APPLICATION NUMBER	FILING OR 371(C) DATE	FIRST NAMED APPLICANT	ATTY. DOCKET NO./TITLE
14/849,458	09/09/2015	Dean Solon	S4079.10001US02

Application Data Sheet 37 CFR 1.76	Attorney Docket Number	SHOALS-59
	Application Number	
Title of Invention	LEAD ASSEMBLY FOR CONNECTING SOLAR PANEL ARRAYS TO INVERTER

FIG. 5

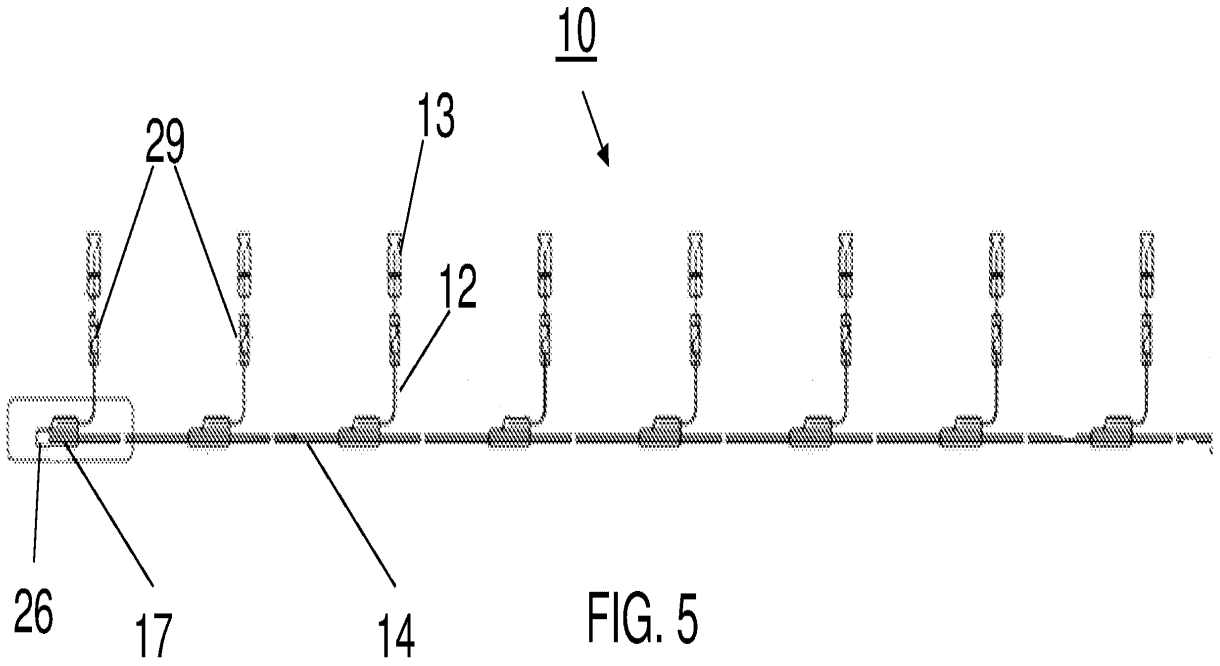
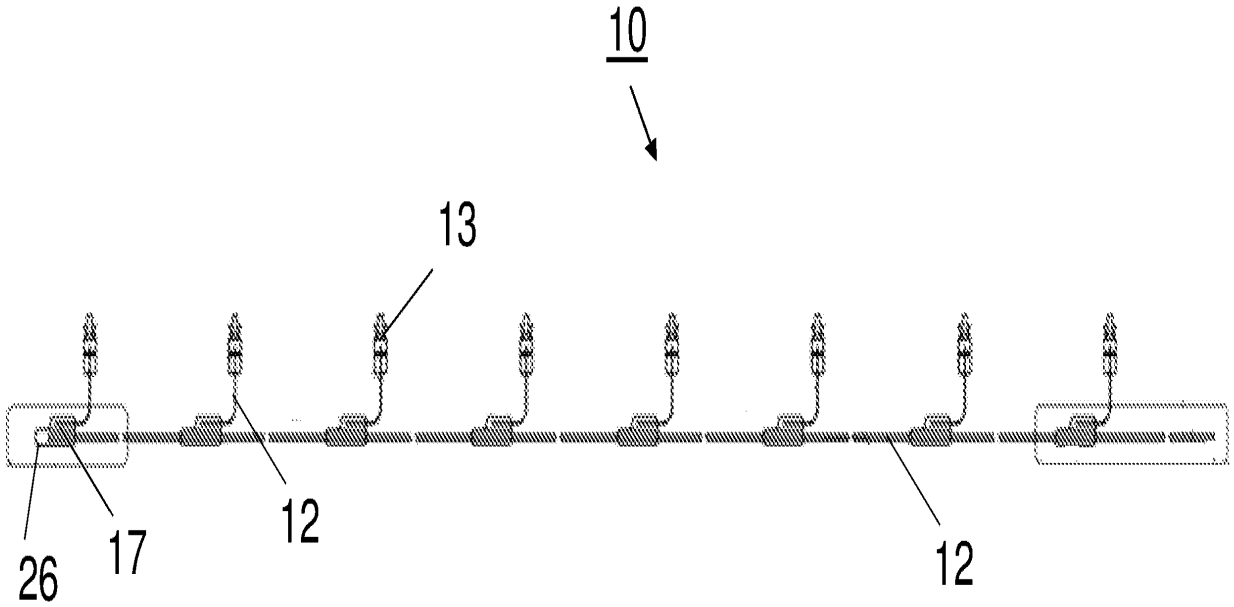
- [ ] The FIG. number label is placed in a location that causes the drawing to be read upside down. FIG(s)
- [X] Data, a reference number, or part of the drawing is truncated or missing, or a lead line has no reference number. FIG(s) 5, 6

A replacement sheet containing FIGS. 5 and 6 is contemporaneously submitted. Annotations are shown below in red:

FIG. 7

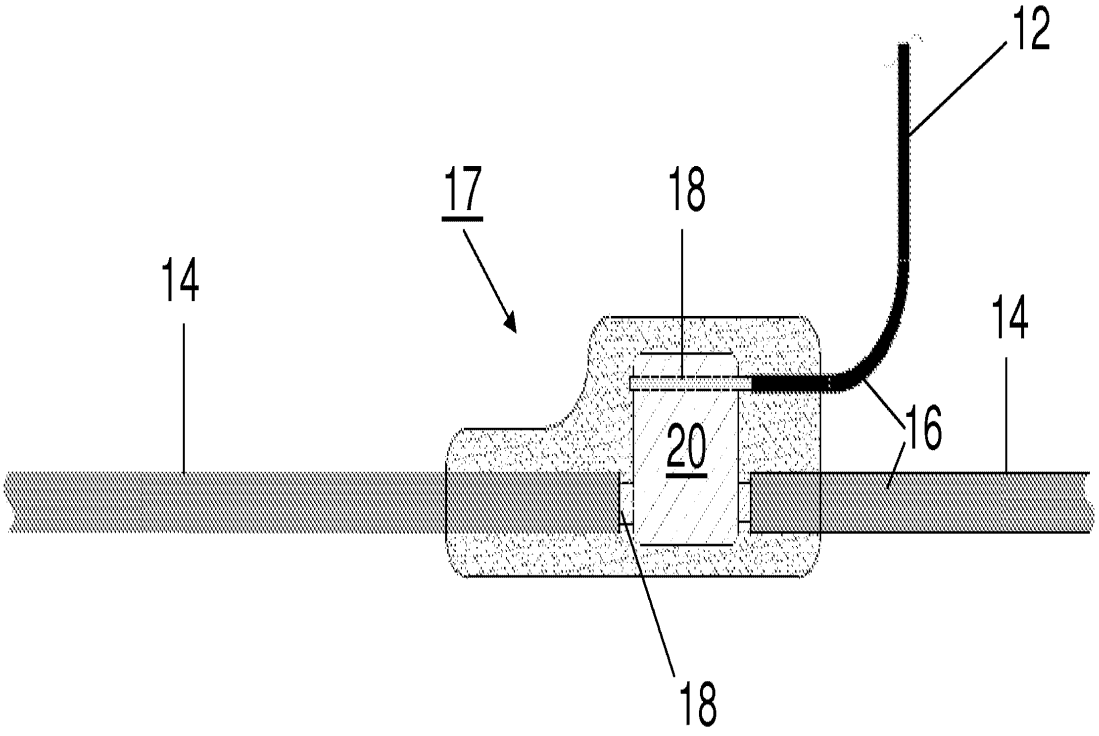
disclosure to support the undermold being in direct contact with the securing means/compression lug. There is no Figure which specifically shows contact between those elements. Figure 7 shows a joint 17 with a shaded overlay, but there is no connection made in the disclosure between the shaded overlay and an element analogous to the claimed undermold, or any reference made to what the overlay represents at all.

FIG. 35

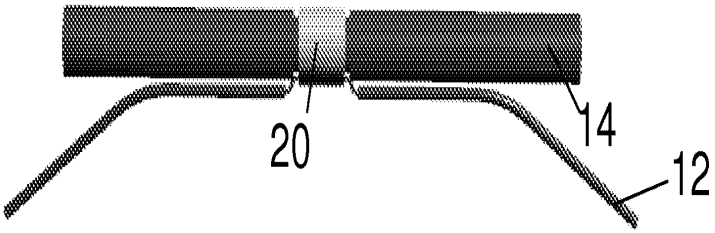
Claims 1 and 6 recite that the inner surface of the undermold is in direct contact with the securing means/compression lug. This limitation is not supported by the disclosure as originally filed. Figure 35 of the instant drawings, for instance shows a connection between the securing means/compression lug 20 at the nexus of the feeder cable 14 and first drop line 12. Figures 33 and 51 show the relationship of an undermold 22 and the nexus. While there is support for the inner surface of the undermold surrounding the securing means/compression lug, there is not enough detail in the

Figure 35 of the instant drawings, for instance shows a connection between the securing means/compression lug 20 at the nexus of the feeder cable 14 and first drop line 12. Figures 33 and 51 show the relationship of an undermold 22 and the nexus. While there is support for the inner surface of the undermold surrounding the securing means/compression lug, there is not enough detail in the disclosure to support the undermold being in direct contact with the securing means/compression lug. There is no Figure which specifically shows contact between those elements. Figure 7 shows a joint 17 with a shaded overlay, but there is no connection made in the disclosure between the shaded overlay and an element analogous to the claimed undermold, or any reference made to what the overlay represents at all.
